URBAN DESIGN GUIDELINES FOR HEIGHT OF BUILDINGS

Map 4

NOTE: This map has been changed by amendments to the General Plan. This map is intended only as a temporary placeholder and will be replaced by final maps illustrating these amendments in graphic form.

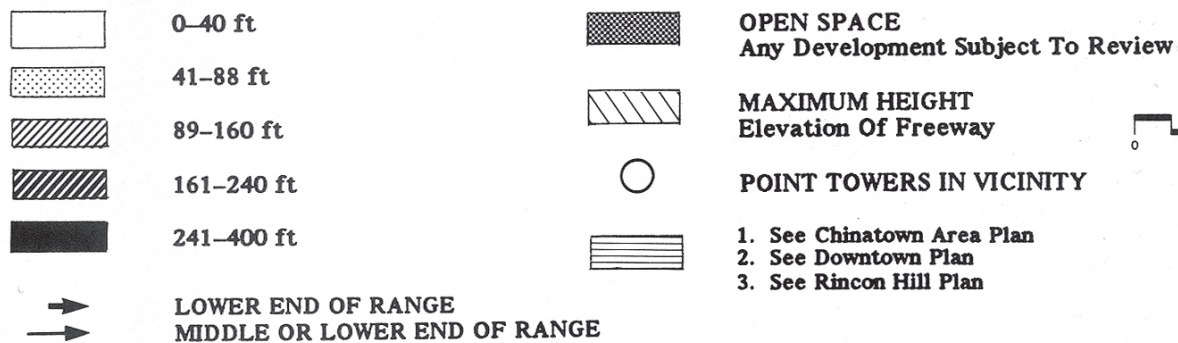
- *Delete the shaded areas within the Mission Bay area and add a boundary around the Mission Bay area with a line that leads to a reference that states "See Mission Bay North and Mission Bay South Redevelopment Plans." For Assessor's Blocks 3796 (Lots 1 and 2), 3797(Lot 1), and a portion of 3880, place an asterisk on the parcels with a reference on the bottom of the page that states "See the Mission Bay Guidelines adopted by the Planning Commission"*

- *Add a boundary area around the Hunters Point Shipyard area with a line that leads to a reference that states "See Hunters Point Redevelopment Plan and Hunters Point Shipyard Area Plan"*

- *Add a boundary area around Candlestick Point with a line that leads to a reference that states "See Candlestick Point SubArea Plan and Bayview Hunters Point Redevelopment Plan"*

- *Add: "See Mission Bay Guidelines adopted by the Planning Commission"*
- *Add reference under #2 to Transbay: "See Downtown Plan and Transbay Redevelopment Development Controls and Design for Development Plan"*

- *Change Lot 1 in Assessor's Block 766, so that it has a height designation of 161-240 feet. (BOS Ordinance 0209-01)*
- *Add a boundary area around the Balboa Park Station plan area with a line that leads to a reference that states "See the Balboa Park Station Area Plan" (BOS Ordinance 0060-09)*

- *Add a boundary around the Visitacion Valley Schlage Lock area with a line that leads to a reference that states "See Redevelopment Plan for the Visitacion Valley Schlage Lock Project. (BOS Ordinance 0072-09)*

- *Insert boundary around CP and refer to the CP Subarea Plan and BVHP and Redevelopment Plan; revise notation about HPS to refer to the HPS Area Plan as well as the HPS Redevelopment Plan. (BOS Ordinance 0203-10)*

- *Delete the shaded within the Parkmerced site; add a boundary line around the Parkmerced site encompassing Assessor's Blocks 7303 (Lot 1), 7303A (Lot 1), 7308 and 7309 (both Lots 1), 7309A (Lot 1), 7310 and 7311 (both Lots 1), 7315 through 7319 (all Lots 1), 7320 (Lot 3), 7321 through 7323 (all Lots 1), 7325 and 7326 (both Lots 1), 7330 (Lot 1), 7331 (Lot 4), 7332 (lot 4), 7333 Lots 1 and 3), 7333A (lot 1), 7333B (lot 1), 7333C (Lot 1), 7333D (Lot1), 7333E (Lot1), 7334 through 7345 (all Lots 1), 7345A (Lot 1), 7345B (lot 1), 7345C (Lot 1), 7356through 7370 (all Lots 1); and add a reference that states "See Parkmerced Special Use District, Section 249.64 of the Planning Code, and Sectional Map HT13 of the Zoning Maps". (BOS Ordinance 0092-11)*

- *Insert diagram to show Treasure Island and Yerba Buena Island. Add a boundary around Treasure Island and Yerba Buena Island and refer to the TI/YBI Area Plan and applicable Design for Development. (BOS Ordinance 0097-11)*

- *Add a boundary area around Executive Park with a line that leads to a reference that states "See Executive Park Subarea Plan of the Bayview Hunters Point Area Plan." (BOS Ordinance 0143-11)*

- *In legend, amend text to read: "2. See Downtown Plan including Transit Center District Sub-Area Plan." (BOS Ordinance 0185-12)*
- *Change the height for the proposed St. Luke's Campus Hospital tower site (the portion of the St. Luke's Campus site that begins 45' from the northwest corner of the property in an easterly direction along the north property line; then runs 134' easterly along the north property line; then runs perpendicular 228' southerly to a point perpendicular to the south property line; then runs 134' westerly along the south property line; then returns 228' in a northerly direction to the beginning point) from 41' - 88' to 145'; and the balance of the Campus (the overall Campus consisting of Block 6575/Lots 001,002; Block 6576/Lot 021, and the portion of San Jose Avenue between Cesar Chavez Street and 27th Street and their successor Blocks and Lots) from 41-88' to 105'. (BOS Ordinance 0146-13)*

- *Add a boundary line around the Visitacion Valley/Schlage Lock Special Use District as set forth in Sectional Map SU10 of the Zoning Map of the City and County of San Francisco; and add a reference that states "See Visitacion Valley/Schlage Lock Special Use District." (BOS Ordinance 0151-14)*

- *Add a reference that states, "See Fifth and Mission Special Use District, Section 249.74 of the Planning Code, for buildings therein." (BOS Ordinance 0207-15)*

- *Add shading representative of 41-88 feet height range to the boundaries of the Potrero HOPE SF Design Standards and Guidelines Document. (BOS Ordinance 0019-17)*

- *Add shading representative of 41-88 feet height range to the boundaries of the Sunnydale HOPE SF site. (BOS Ordinance 0020-17)*
- *Add a reference that states, "See Pier 70 Mixed-Use Project Special Use District, Section 249.79 of the Planning Code, for buildings therein." (BOS Ordinance 0227-17)*

- *Add shading representative of 30-160 feet to the boundaries of the India Basin site (BOS Ordinance 0261-18)*
- *Add a boundary area around the Central SoMa Plan area with a line that leads to a reference that states "See the Central SoMa Plan". (BOS Ordinance 0282-18)*

- *Add a shaded area with a new height designation with a range between 65-240 feet in the location of the former Potrero Power Plant, as shown in the Potrero Power Station Special Use District, Planning Code Section 249.87. (BOS Ordinance 0064-20)*

- *Change Lot 001 in Assessor's Block 3971 so that it has a height designation of 89-160 ft. (BOS Ordinance 0057-24)*
- *Add shading representative of 30-190 feet height range to the boundaries of the Stonestown Development Project, as shown in the Stonestown Special Use District, Planning Code Section 249.7 . (BOS Ordinance 208-24)*
